Access Compliance Report

Public Rights-of-Way

Intersection ID: 23503	Main Street: SHARONBROOK_DR	Cross Street: VILLAGE_BROOK_DR	Location: NE
ADA ID: 2D905CAE6DEA	Ramp Type: PerpDiag	Initial Pass/Fail: Fail	Overall Compliance: No
		Severity Score: 37.5

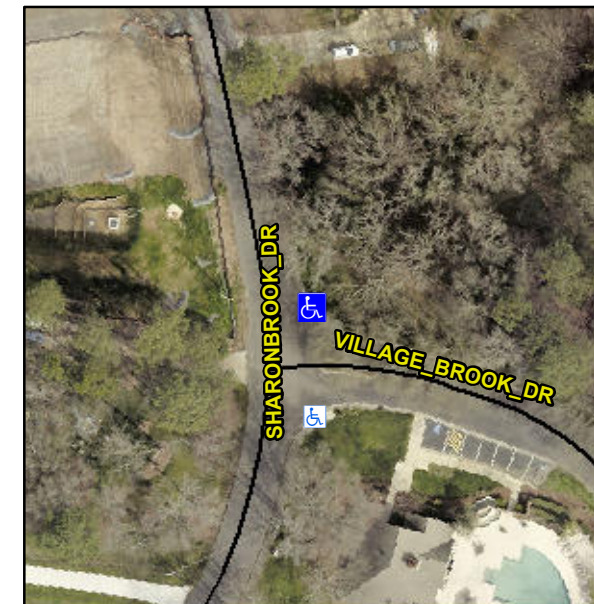
R304.2.2, R304.5.3

Compliance	Description	Data	Compliance	Description	Data
N/A	Ramp Length (in)	48.0	No	Ramp Slope (%)	9.3
Yes	Ramp Width (in)	48.0	No	Ramp XSlope (%)	7.3
N/A	Flare Type LT	N/A	N/A	Flare Type RT	N/A
N/A	Flare Slope LT (%)	N/A	N/A	Flare Slope RT (%)	N/A
N/A	Flare Traversable LT?	N/A	N/A	Flare Traversable RT?	N/A
N/A	Landing Length (in)	N/A	N/A	DWS Provided?	N/A
N/A	Landing Width (in)	N/A	N/A	DWS Contrast?	N/A
N/A	Landing Slope (%)	N/A	N/A	DWS Length (in)	N/A
N/A	Landing X Slope (%)	N/A	N/A	DWS Full Width?	N/A
N/A	Landing Curb? (Y/N)	N/A	N/A	DWS Offset (in)	N/A
N/A	Shared Landing?	N/A			
N/A	Gutter Ponding?	N/A	N/A	Gutter Slope (%)	N/A
N/A	Gutter Lip Ht (in)	N/A	N/A	Gutter X Slope (%)	N/A
N/A	Painted X Walk1?	No	N/A	Painted X Walk2?	No
	X Walk 1 Direction	To W		X Walk 2 Direction	To S
N/A	X Walk 1 Width (in)	N/A	N/A	X Walk 2 Width (in)	N/A
	X Walk 1 Slope (%)	6.7		X Walk 2 Slope (%)	0.7
	X Walk 1 X Slope (%)	1.1		X Walk 2 X Slope (%)	6.4

Remove & Replace Curb Ramp With Two New Directional Ramps or Equivalent.
